**NSLS II**  
**Conventional Facilities Advisory Committee**  
**May 8 & 9, 2008**

The following is a report of the review conducted by the Conventional Facilities Advisory Committee for the NSLS II Project. It is organized according to the charge provided to the committee by the NSLS II Project.

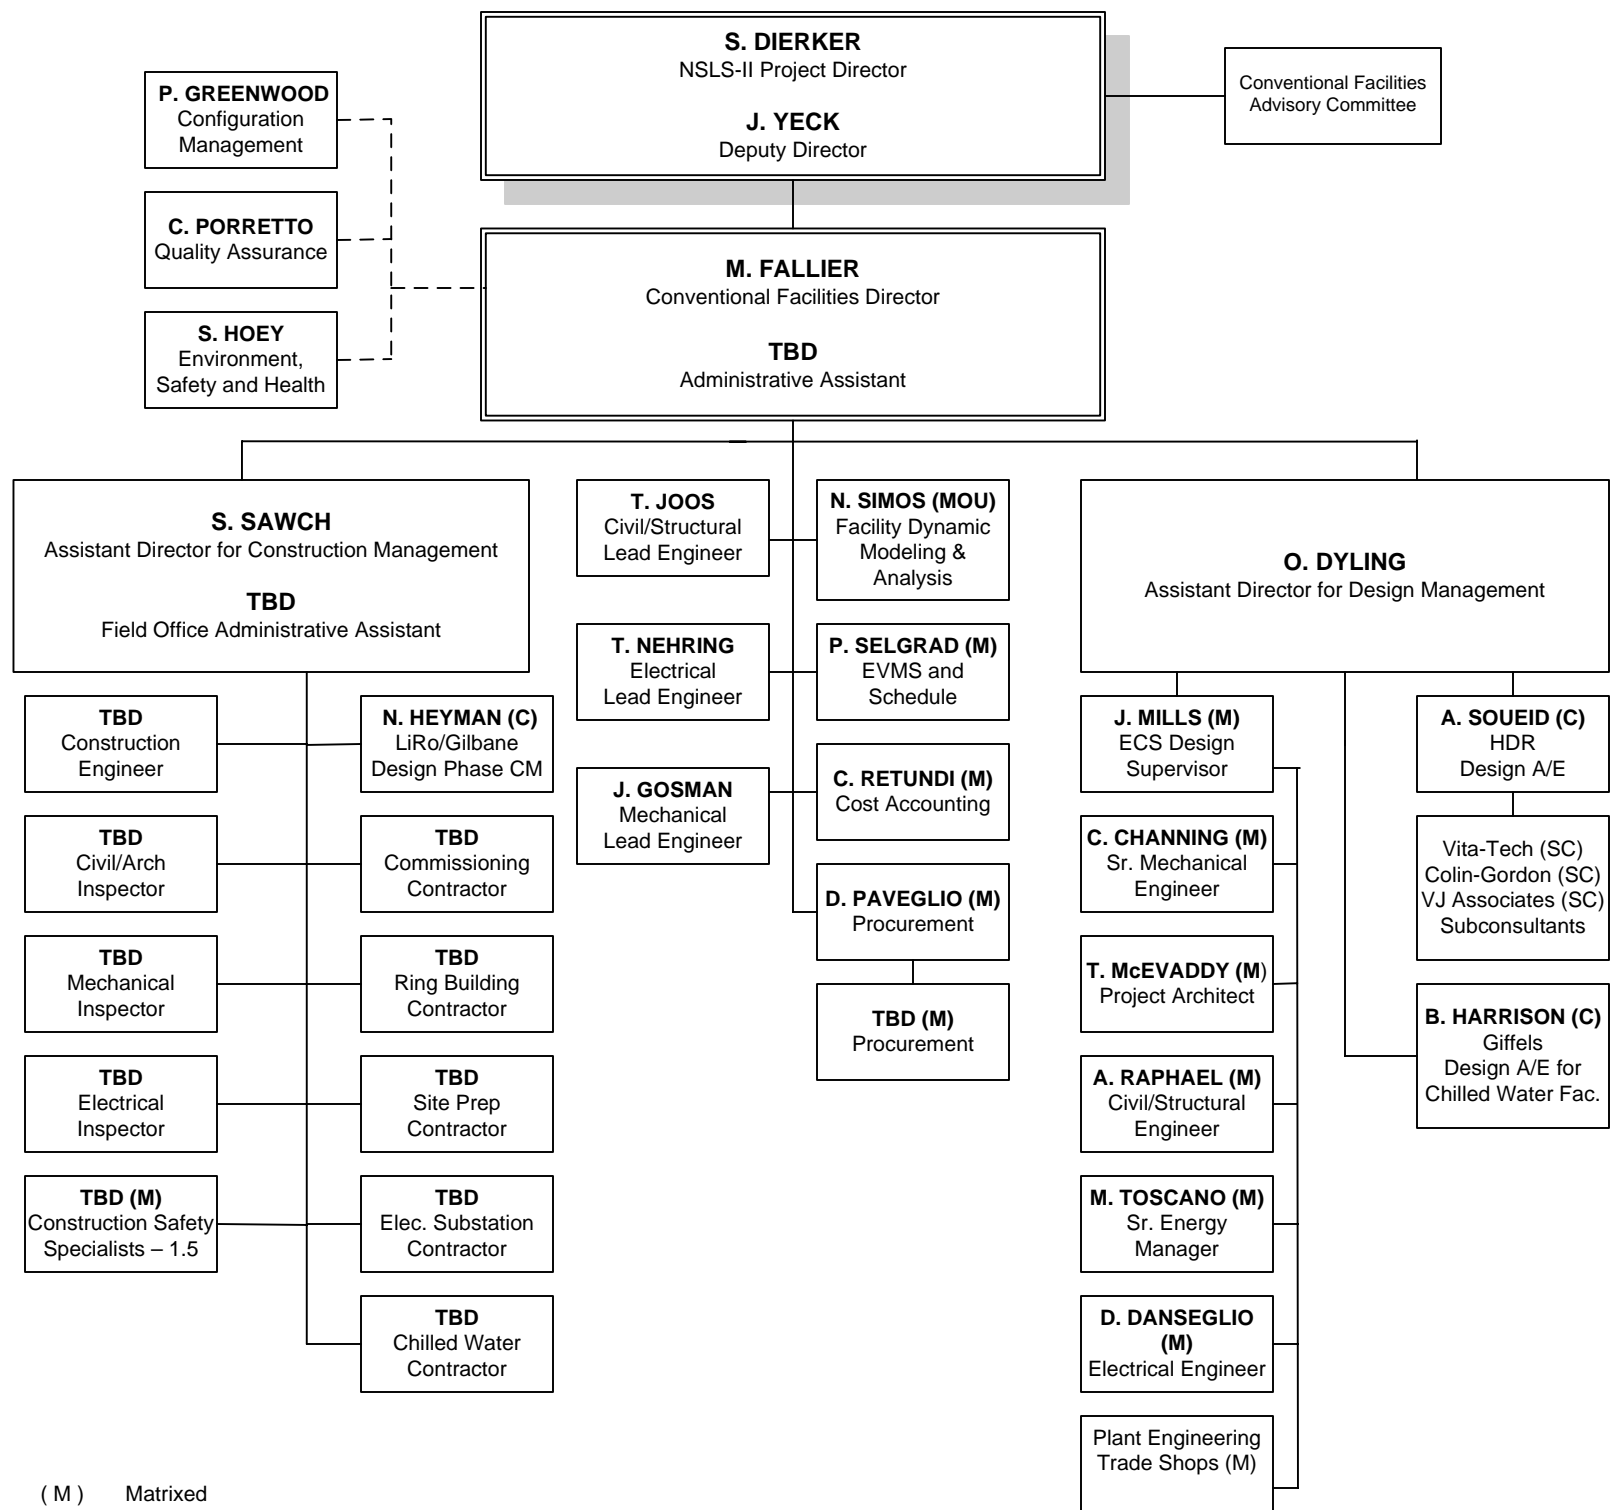
- d) The revised CF organization chart (attached) more clearly defines the roles of the Assistant Director of Design Management and the Assistant Director of Construction Management. Furthermore, it was important to indicate the GC attachment to the project.
